# UNITED STATES PATENT AND TRADEMARK OFFICE

APPLICATION NO.	FILING DATE	FIRST NAMED INVENTOR	ATTORNEY DOCKET NO.	CONFIRMATION NO.
10/686,458	10/14/2003	Robert Bland	2003P14123US	7250

**Office Action Summary**

**DETAILED ACTION**

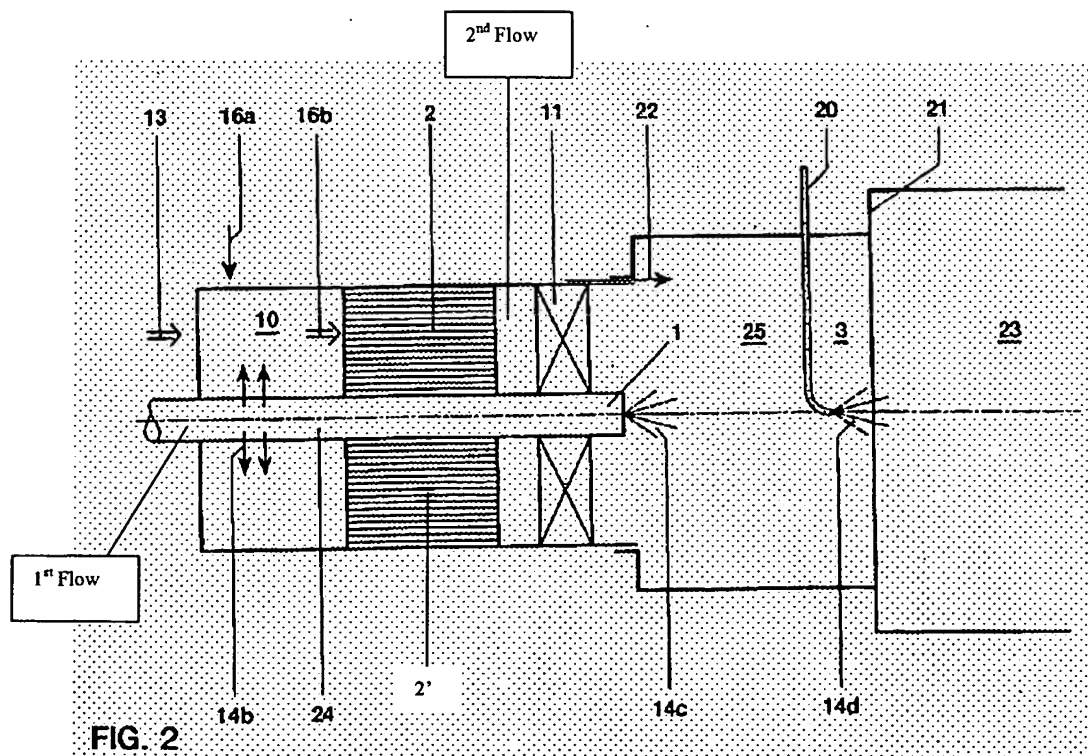
With respect to claim 7, **Joos** teaches a catalytic combustor system for a turbine engine comprising: at least one pilot nozzle 1 providing a first flow exiting the pilot nozzle, at least one catalytic module 2, 2' providing a second flow exiting the plurality of catalytic modules, wherein at least a portion of the second flow is substantially adjacent to at least a portion of the first flow; and at least one vortex forming device 11 positioned substantially within the path of the second flow, wherein at least one vortex is formed in at least a portion of the second flow, wherein the at least one vortex forming device includes a plurality of surfaces (not shown but inherent), whereby at least a portion of the first flow mixes with at least a portion of the second flow. **Joos** does not schematically show the details of the vortex-forming device 11, and thus does not schematically show that a substantial majority of the surfaces of said vortex forming device are substantially oblique to the path of the second flow. However, **Saito** teaches a conventional

vortex-forming device 9 which includes a plurality of surfaces 38, wherein a substantial majority of the surfaces of said vortex forming device 9 are substantially oblique (incline) to the path of a second flow (air passing through said vortex device) in order to provide a vortex to said flow and enhance mixing of this second flow with a first flow. Thus, as taught by **Saito**, it would have been obvious to a combustor designer (one of ordinary skill in the art) at the time the invention was made to have provided **Joos'** vortex-forming device with **Saito's** oblique surfaces in order for **Joos'** vortex-forming device to properly create a vortex and enhance mixing of the fluid(s). See particularly **Figure 2** of **Joos**; and **Figures 1, 6** of **Saito**.
